# Shorewood Board of Appeals Meeting Agenda

October 11, 2016 at 5:30 P.M.

RE: 2500 E. Olive Street Fence

RE: Board of Appeals – 3564-66 N. Frederick Ave

# Yellow Line- Front Yard Boundary

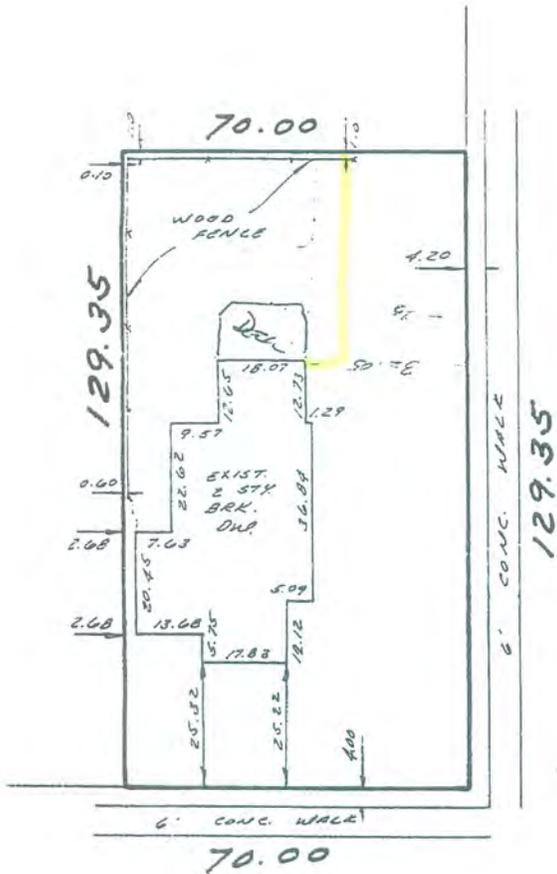
Olive Street is the front yard and the survey indicates the house is 32 feet back from the front property boundary. The inspector measured the fence and it is less than 16 feet from the front boundary.

The height of the fence in the front yard varies between 5’1” to 5’7”. Only the front yard fence was replaced.

# 3564-66 Frederick

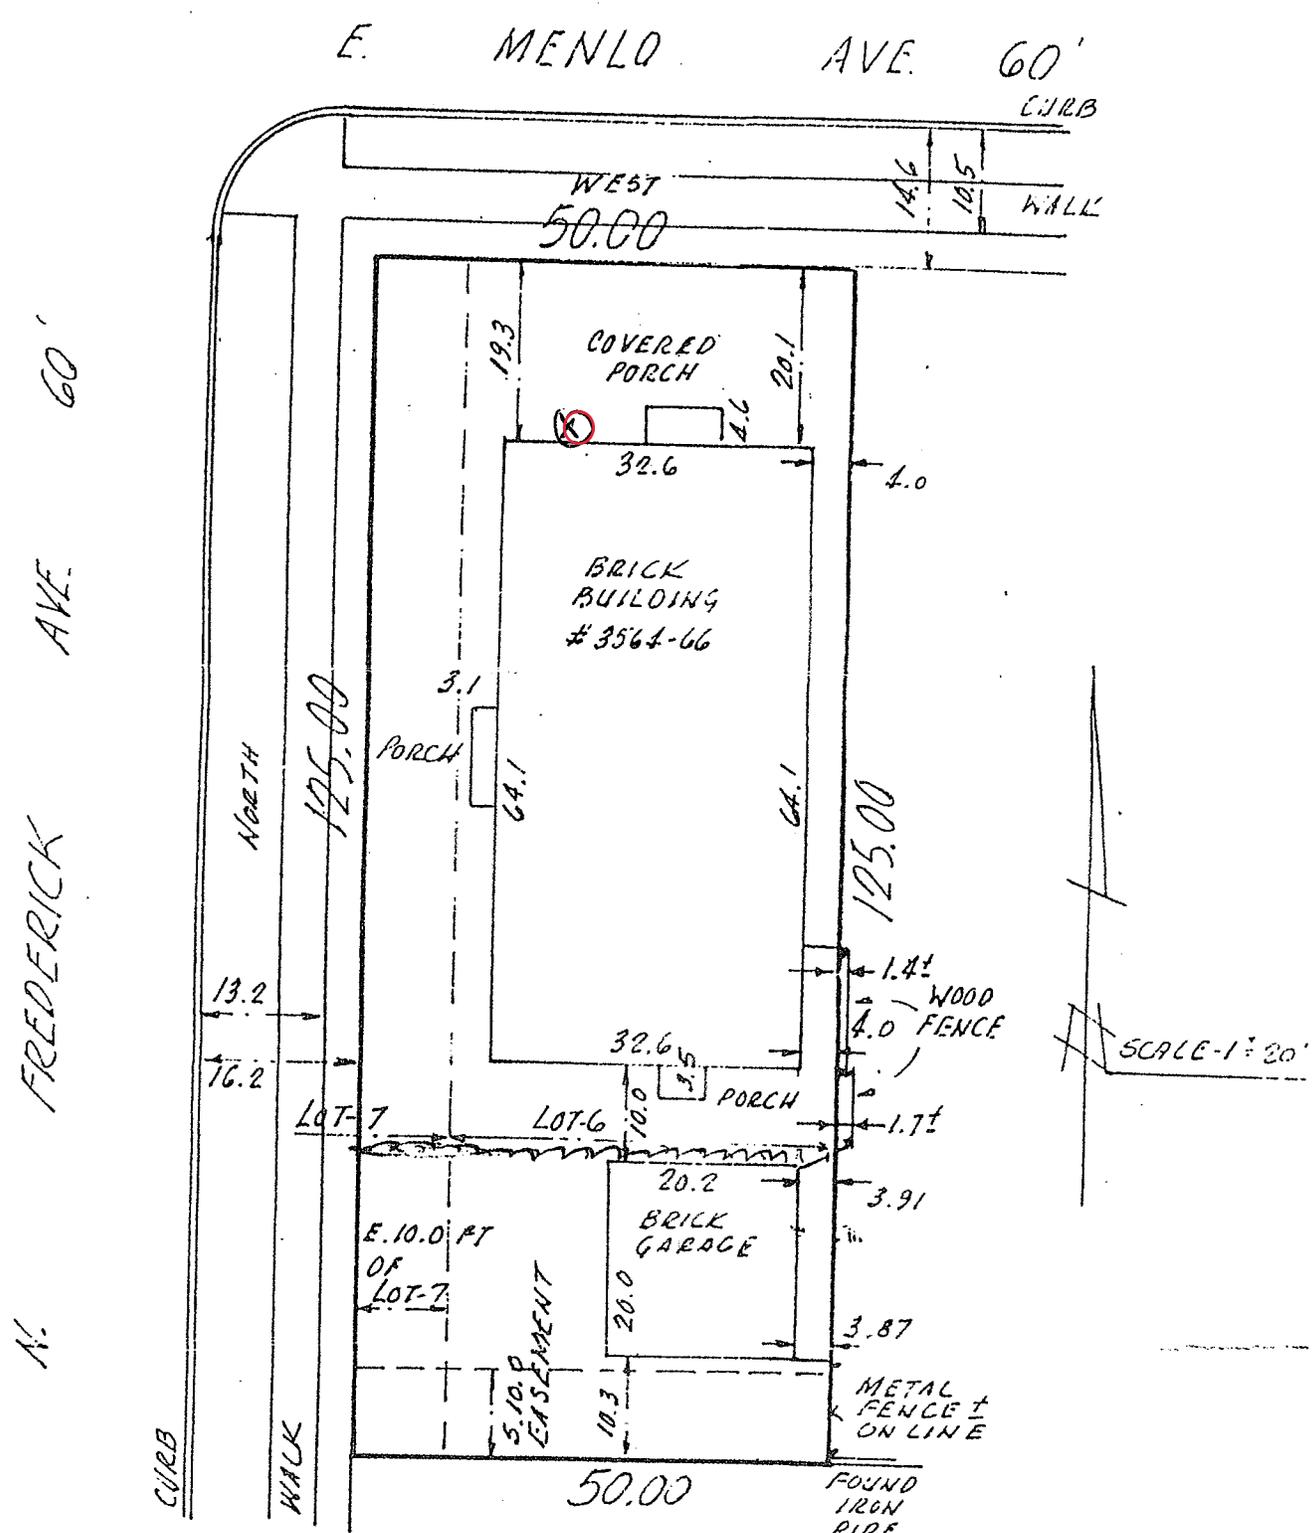
To meet zoning code setbacks, any structure on this parcel must be 31.25 feet from the street side property boundary. Per the attached survey, the width of the lot is 125 feet and the house is located 19.7 feet (averaged) from the side boundary along Menlo Avenue. The AC unit would be completely within the side yard setback. Given the house is not setback 31.25 feet from the property boundary, it is a legal nonconforming structure.

The street side yard setback for the property is 31.25'. The property is 19.7' feet (averaged) from the North property line making it an existing non-conforming parcel; placing the condensing unit on the North side of the dwelling would make it entirely within the street side yard setback which is prohibited.

Proposed slab

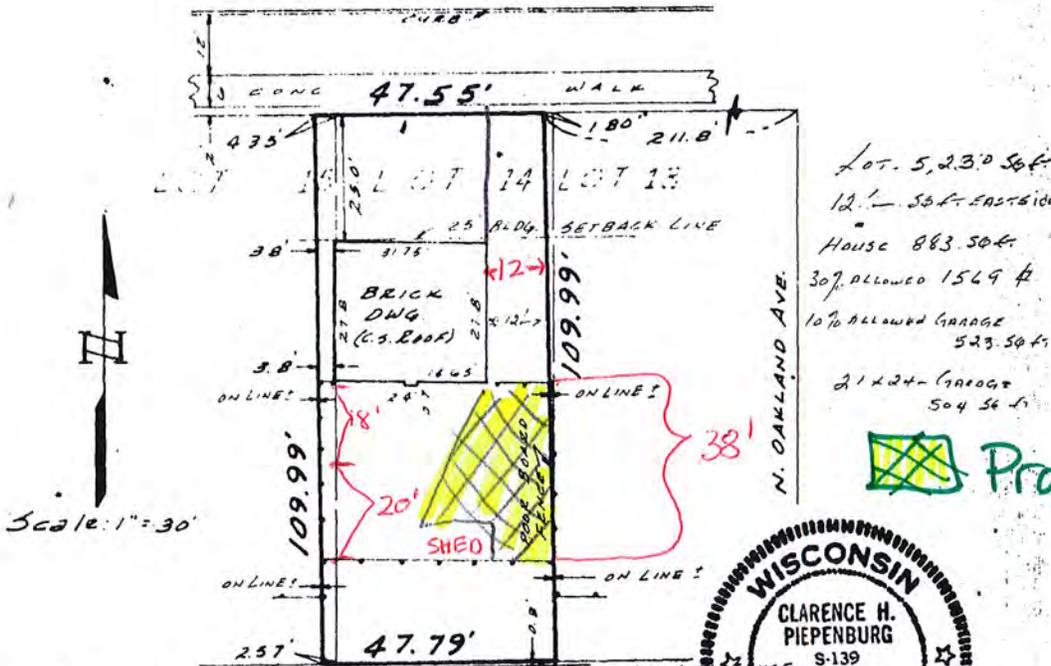
The lot is 47.55 feet wide and 109.99 feet deep. The pictures provided show the steep grade change at the rear of the property- approximately 20 feet of the depth of the lot is this grade change. A contour map is provided and shows that there is a seven to eight foot drop down from the proposed parking slab to the rear parcel boundary.
